New Albany Planning Commission Meeting Agenda
Monday, August 17, 2026, 7:00 p.m.

New Albany Planning Commission
Monday, July 20, 2026 Meeting Minutes - DRAFT

**Planning Commission Staff Report
July 20, 2026 Meeting**

**6600 NEW ALBANY-CONDIT ROAD OFFICE
FINAL DEVELOPMENT PLAN**

Image: Proposed site layout, showing the buildings, pavement and parking, and general landscaping.

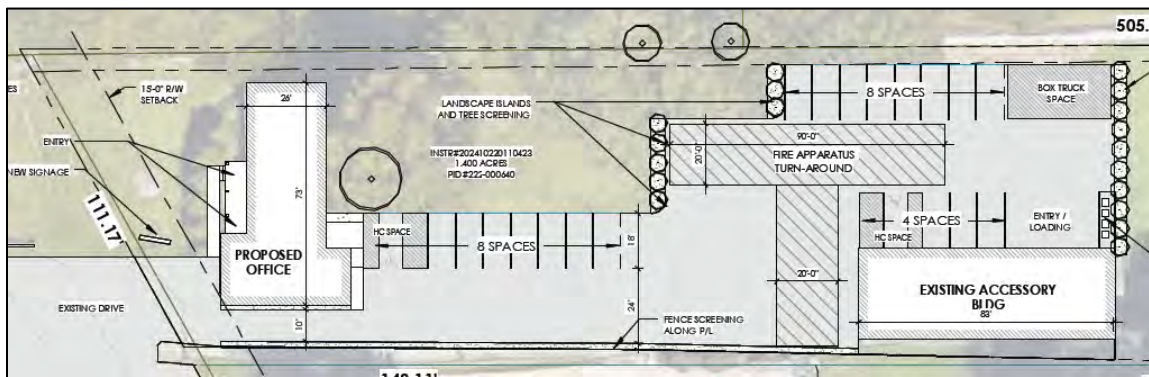
1. Vehicular access to the subject parcel is provided from New Albany-Condit Road. The application for the rezoning was approved with a condition that the final development plan shall include details to further delineate the route to access the driveway from the driveway on the parcel to the south of and adjacent to this zoning district for review and approval by the Planning Commission. At a minimum, the applicant is proposing to extend the existing median between the two properties to better delineate the entry drives. Engineering staff conducted a preliminary review of the site access and noted that if a typical commercial curb cut were to be installed, the adjacent property would likely need to connect its driveway to the commercial driveway due to the width and curb radius, requiring cross-access and removing direct access to New Albany-Condit Road. As such, the preliminary recommendation of the City Engineer was to allow the driveway to remain as it currently exists; another recommendation is to remove or reduce the pavement to the existing garage door and include a more standard curb radius on the northern side of the entry drive.

2. A Traffic Access Study has been completed, which found that no turn lanes are warranted at the site access. The City Engineer reviewed the study and concurred with the results. Actionable items recommended by the City Engineer have been included in the City Engineer's Comments section of this report.

3. A total of 20 parking spaces is proposed, which is the maximum number allowed (zoning text V(A)). All parking is located to the rear of the main building and no farther back than the easternmost portion of the accessory structure. Additionally, one loading space is proposed and one parking space is included at the northeast of the lot for a box truck.
4. The following parking requirements are applicable to the proposed development and are contained in C.O. 1167:

Image: Proposed exterior of main building.

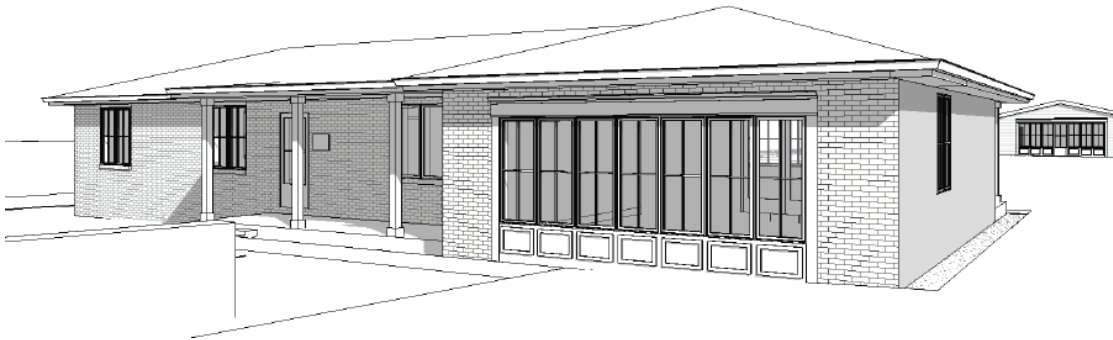
1. According to the DGRs, the key to sensitive renovation of existing buildings is to observe and respect the physical context of the property and design new elements in a sensitive way that fits in with existing structures. Residential buildings can be converted to commercial uses, but they should retain the residential character and design elements. Construction will observe the setback appropriate for the streetscape and the context of the existing buildings on and near the property.

2. The renovations proposed in the final development plan are generally aligned with applicable sections of the DGRs. The main renovations proposed by the final development plan include:

Re: 6600 NA Condit Rd.
Final Development Plan

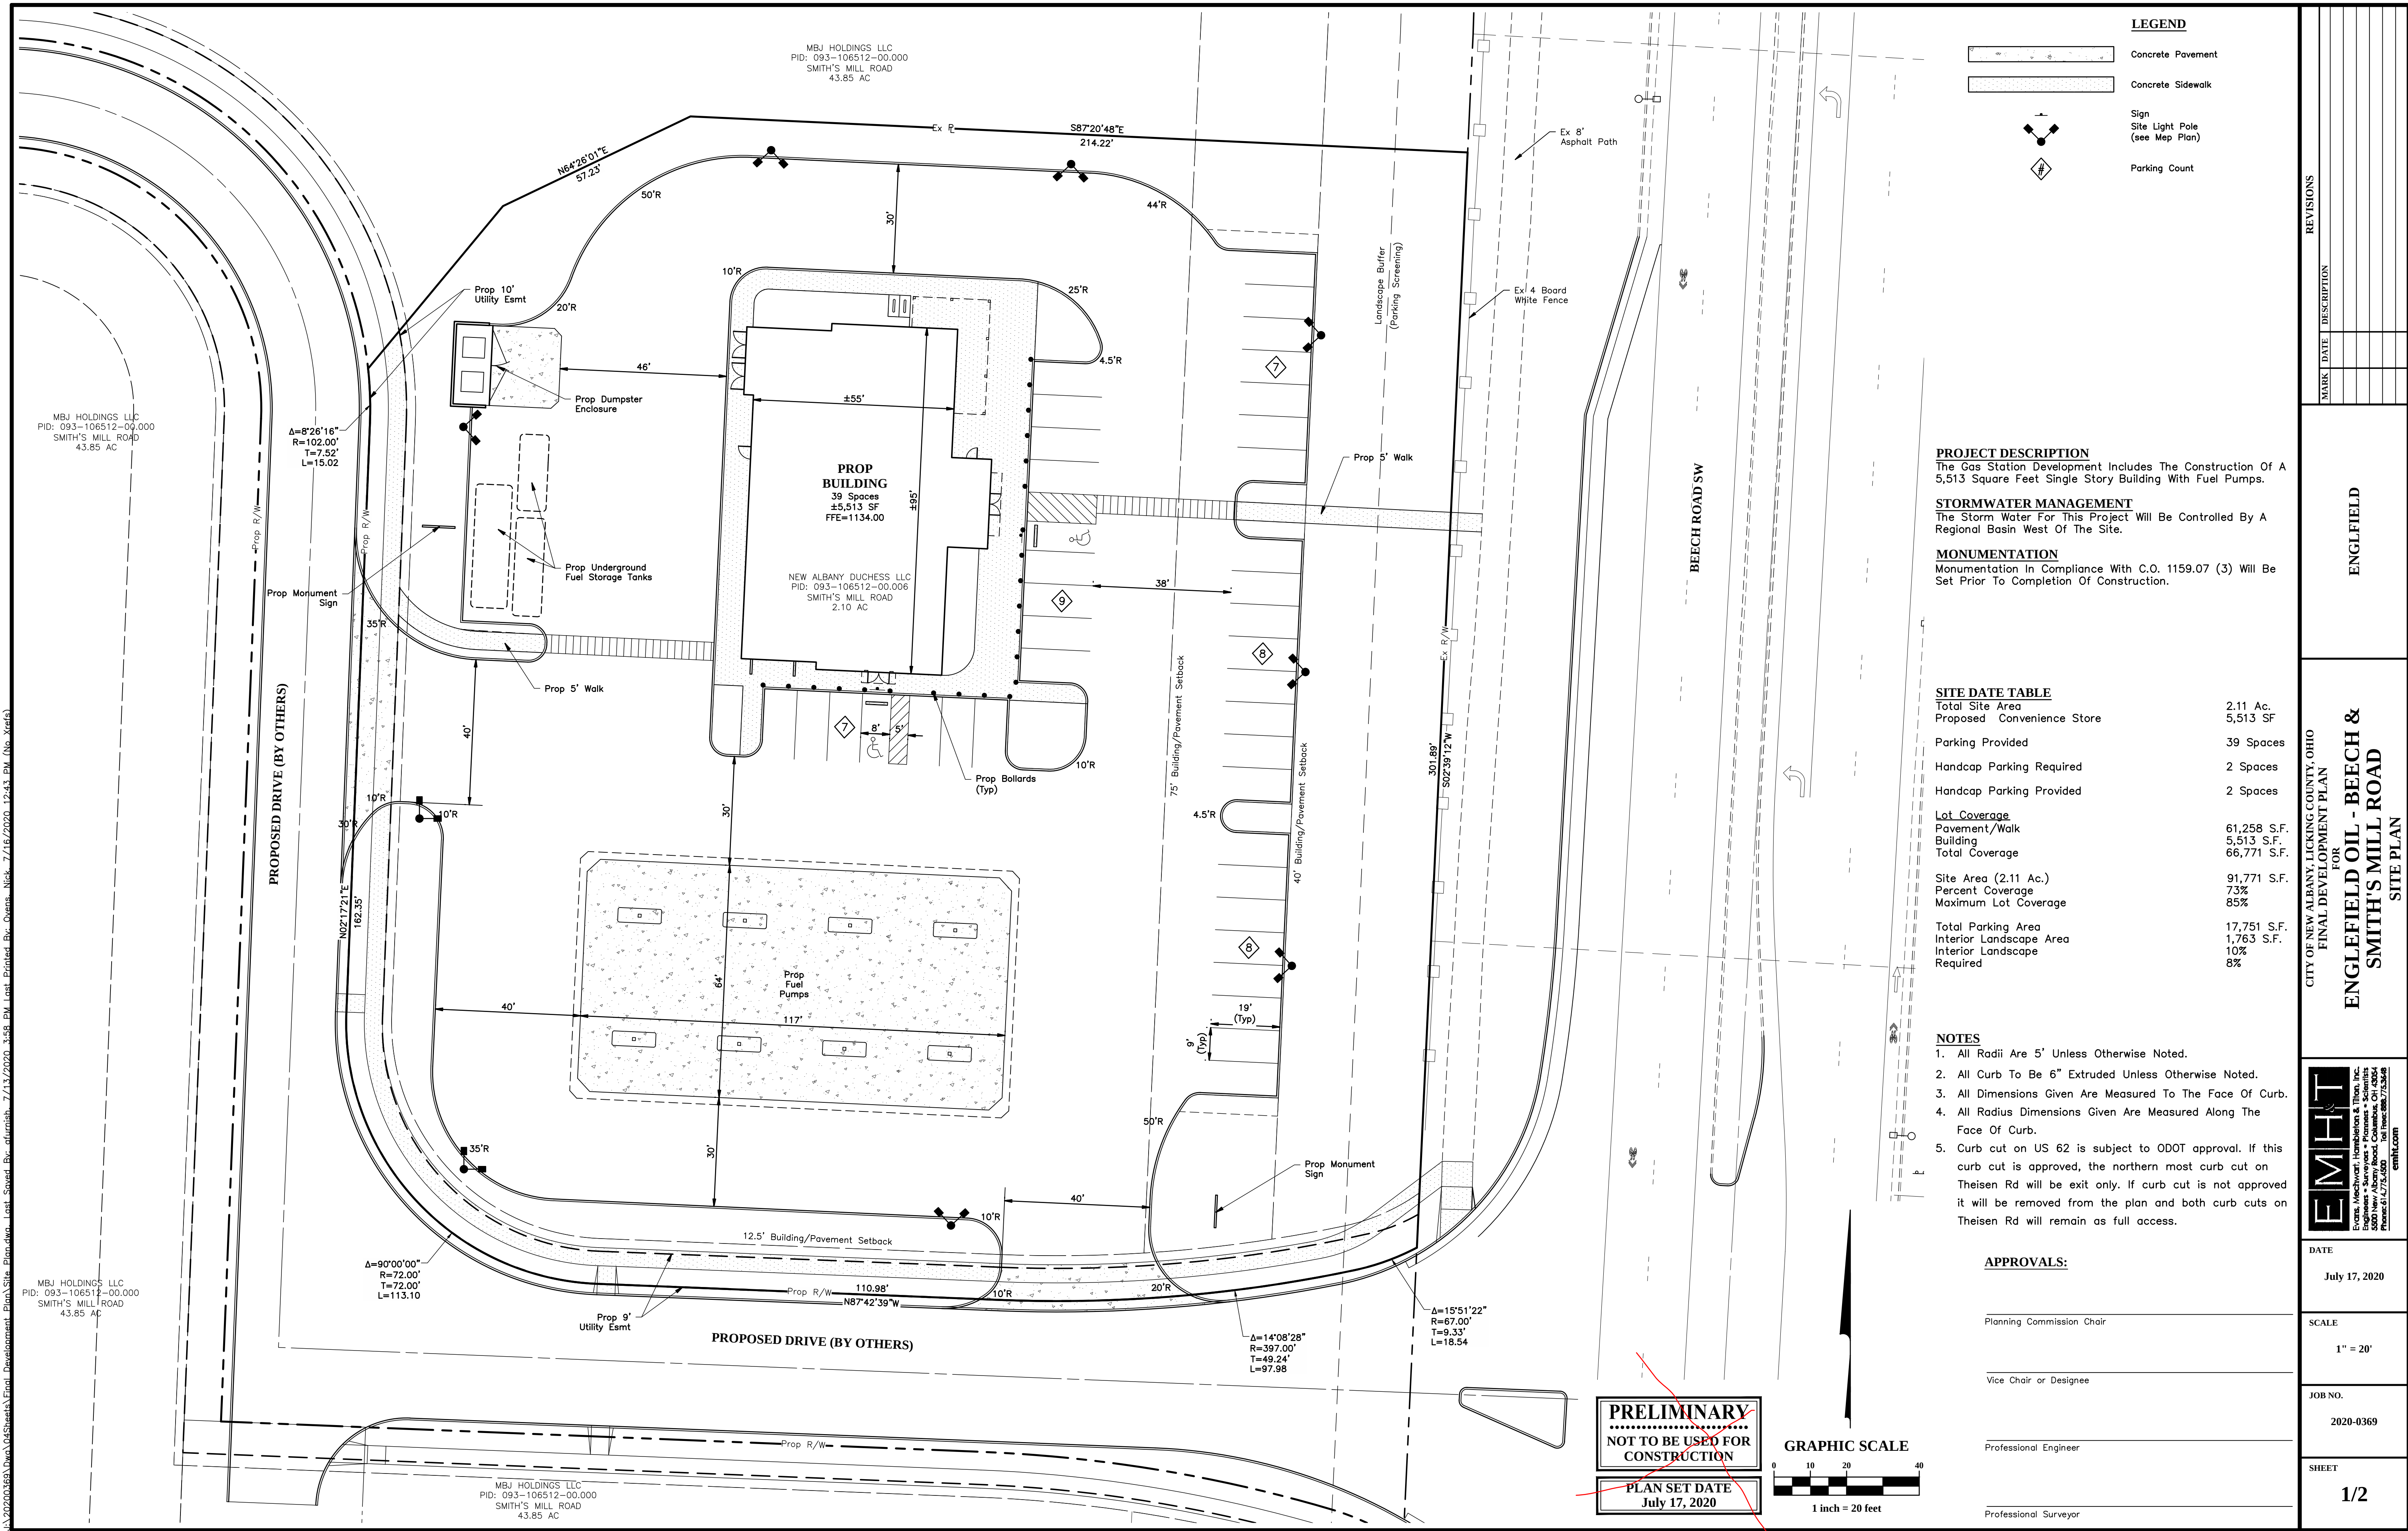
1. Refer to Exhibit A provided with this memorandum. Add the notes and signature block indicated to the Cover Sheet.
2. Provide evidence that all existing private well/septic systems have been abandoned in accordance with all applicable environmental regulations.

3. Show how water and sanitary service will be provided.
4. Existing r/w is approximately 70' and appears sufficient to support the project.
5. Show ODOT Limited Access R/W on the plans and advise if an ODOT permit is required to support the project.

6. Provide a fire truck turning radius analysis and obtain Fire Department approval.
7. We recommend that the existing drive be removed and that a commercial drive be provided similar to other projects in this area.

8. Show major flood routing on the grading plan and design the driveway so that most of the runoff is directed away from the public road.
9. Show stop signs/bars at the driveway curb cut and add site distance triangles. Remove impediments to motorist view.

10. Work with staff to determine what improvements in public r/w are required to support the project.
11. Add a table showing parking stalls required/provided and ADA stalls required/provided.

12. Provide more information about anticipated traffic volumes.
13. Provide a photometrics plan for review and approval.
14. We will further evaluate construction related details once detailed construction plans become available.

Waivers A & B. Waivers to reduce the minimum percentage of lot width that a townhome building must occupy (90% to 76%); and to reduce the minimum required lot size for townhome lots (25' to 22').

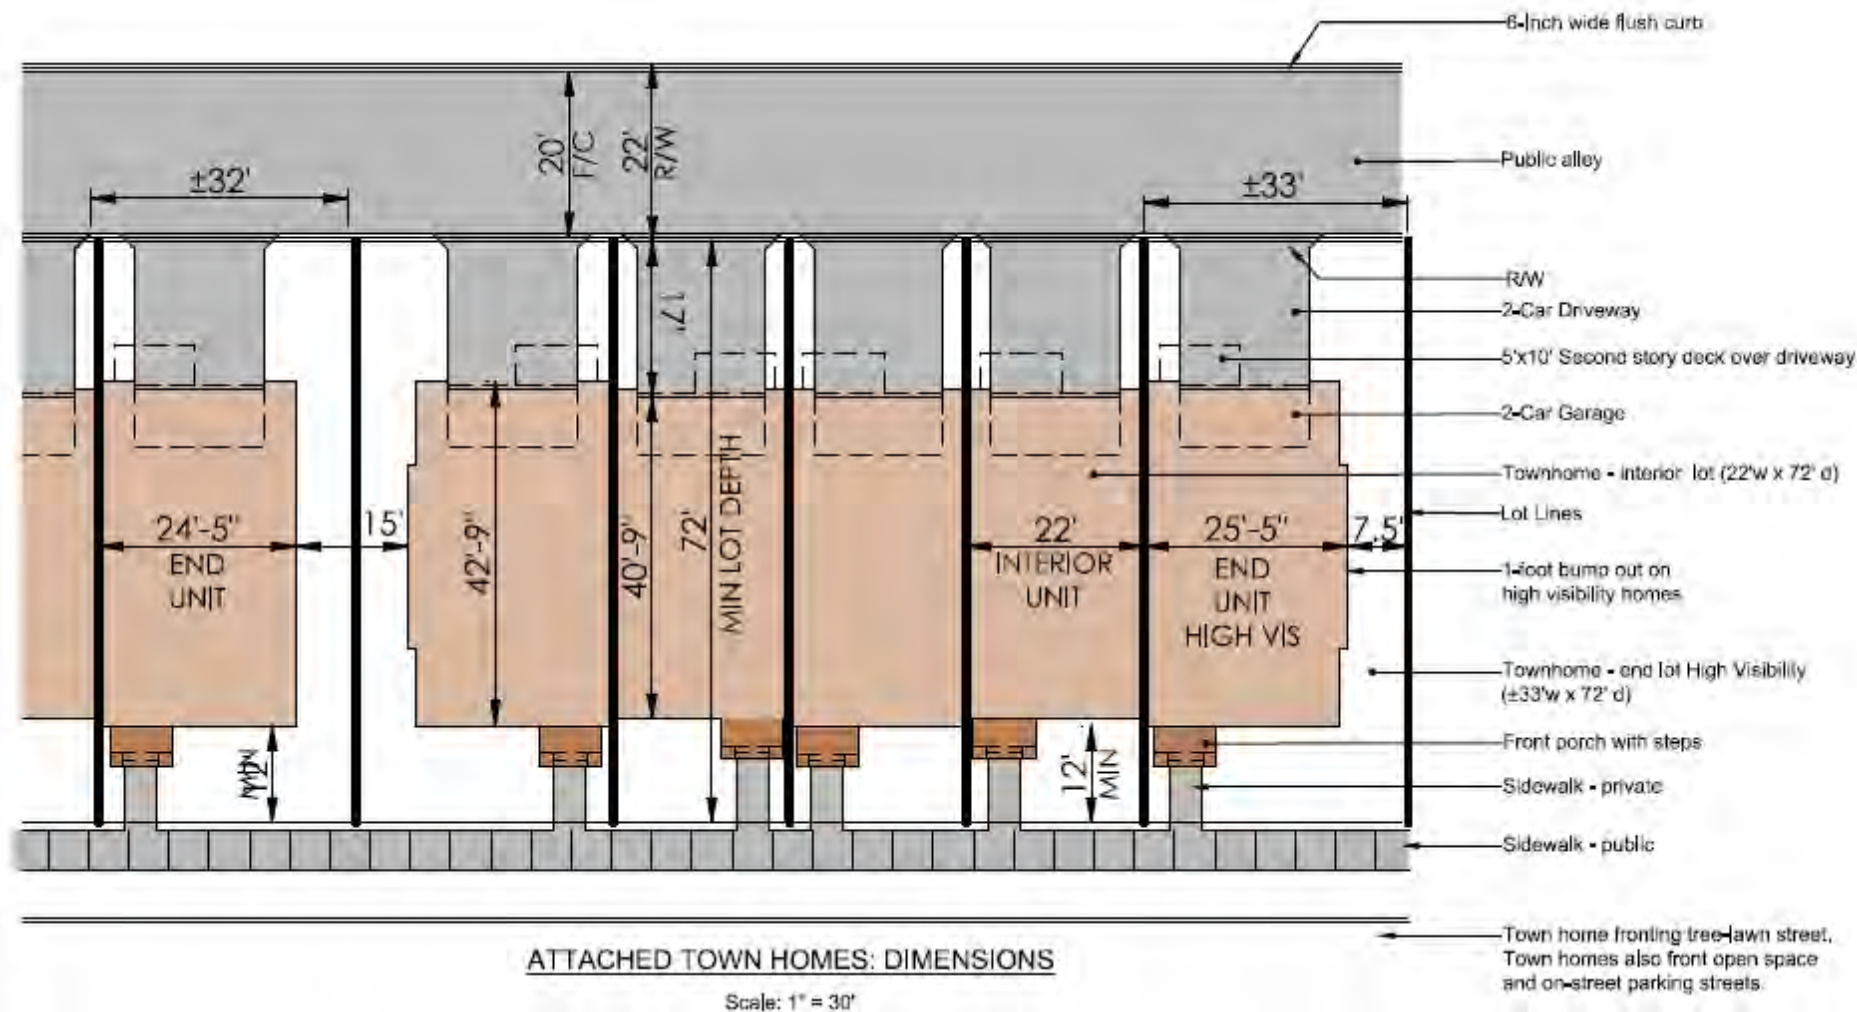
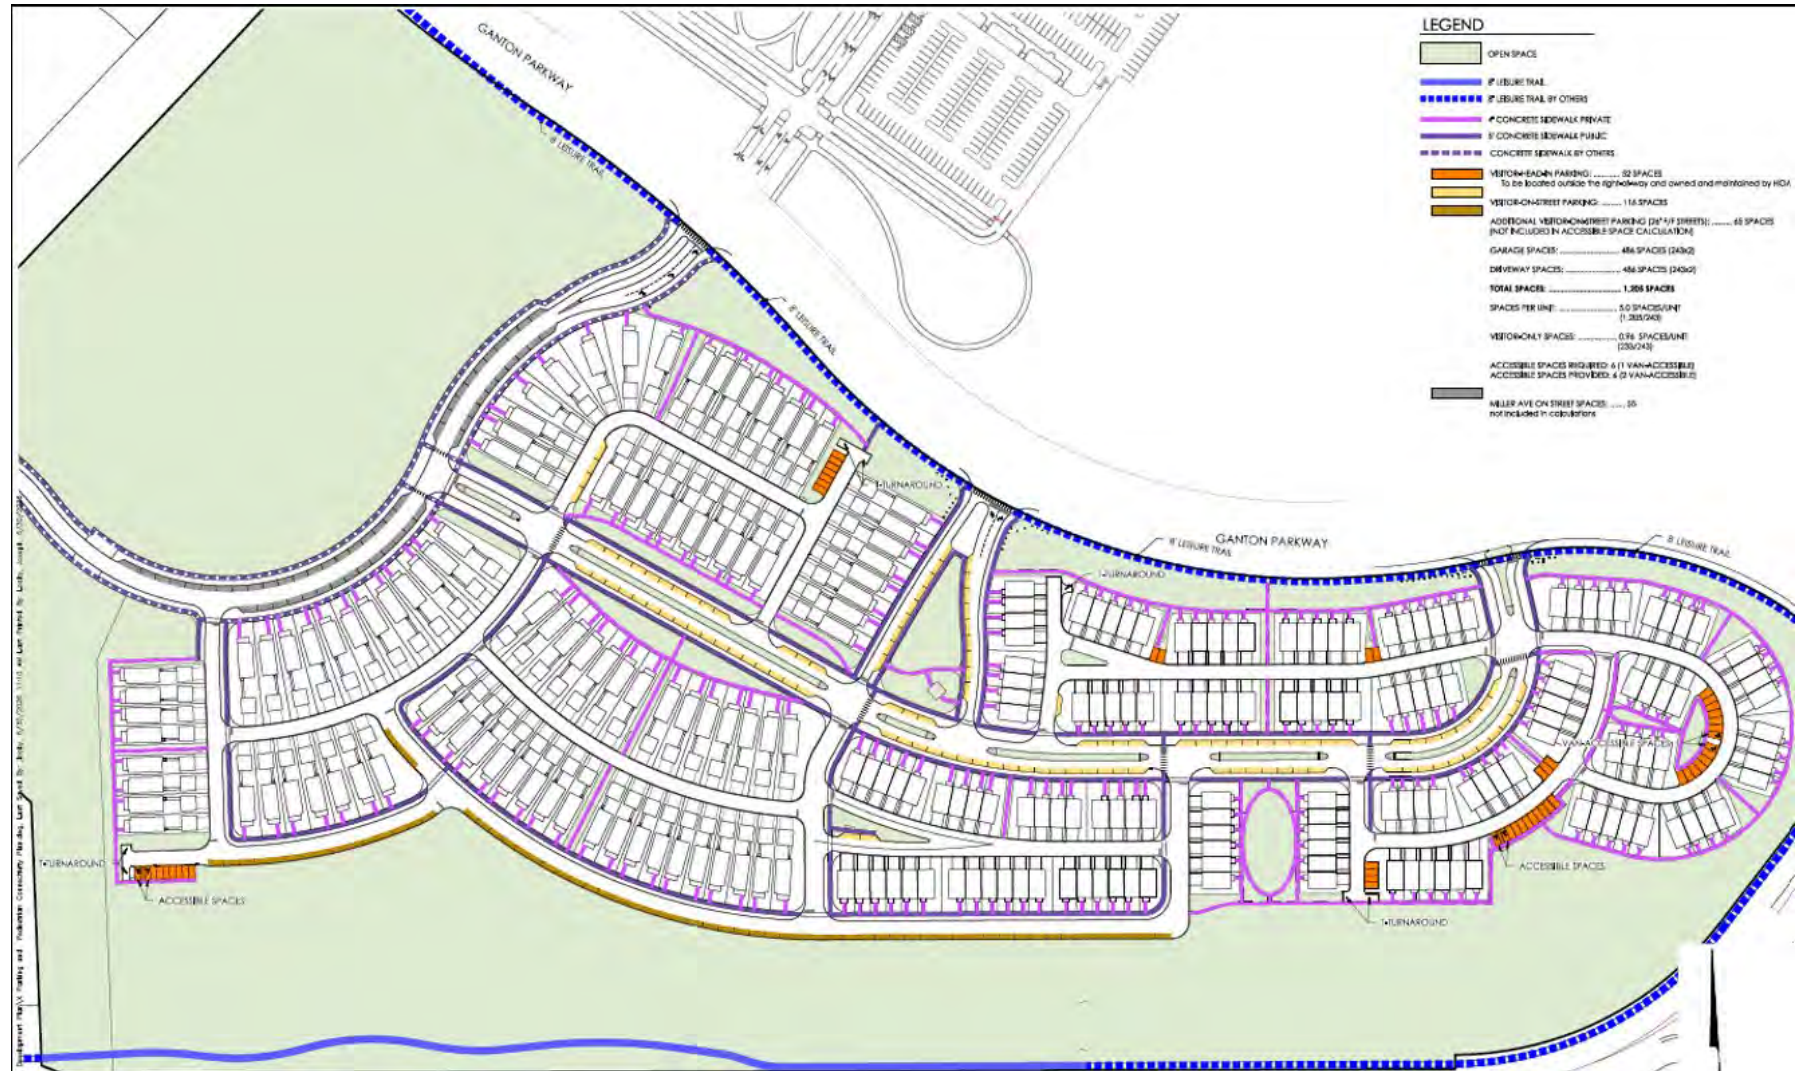
Planner II Saumenig explained that taken together, Waiver A and Waiver B provide a more appropriate development pattern for the Village Center. Strict application of the lot coverage rule would result in 6-foot spacing between the side facades of the townhomes, which, due to the curvature of the road, will look like an endless row. The requested 22-foot interior width is consistent with the compact form of urban townhomes and would create a 15-foot side yard. The reduction in interior width coupled with the added end-unit spacing will enhance the streetscape.

Waiver D. Waiver to allow double-bay garage doors.

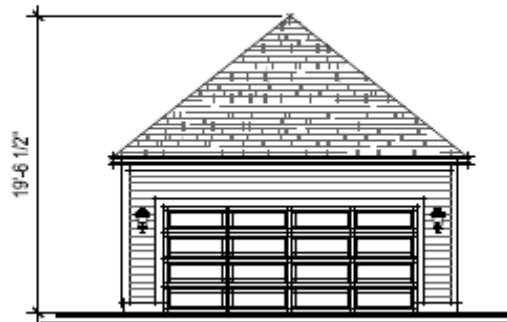
4. Waiver from Section 2 of the Village Residential DGRs, subsections II.B.3 and III.B.3 to allow double-bay garage doors.

Waiver E. Waiver to eliminate the requirement for shutters, when used on a building elevation of a home, must be used on all windows of that elevation.

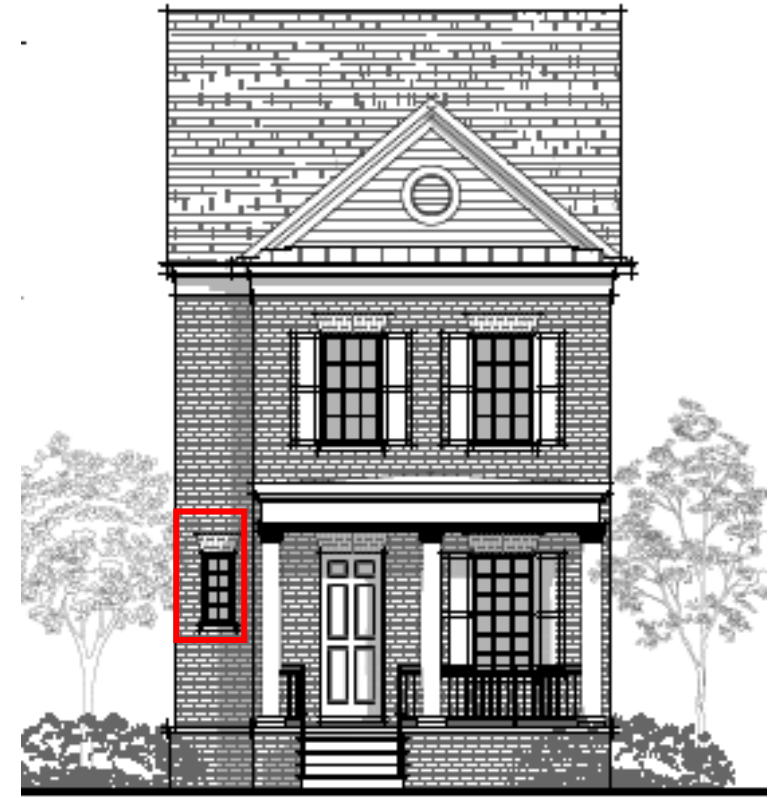
Planner I Henderson responded that the shutter requirement does not apply to townhomes.
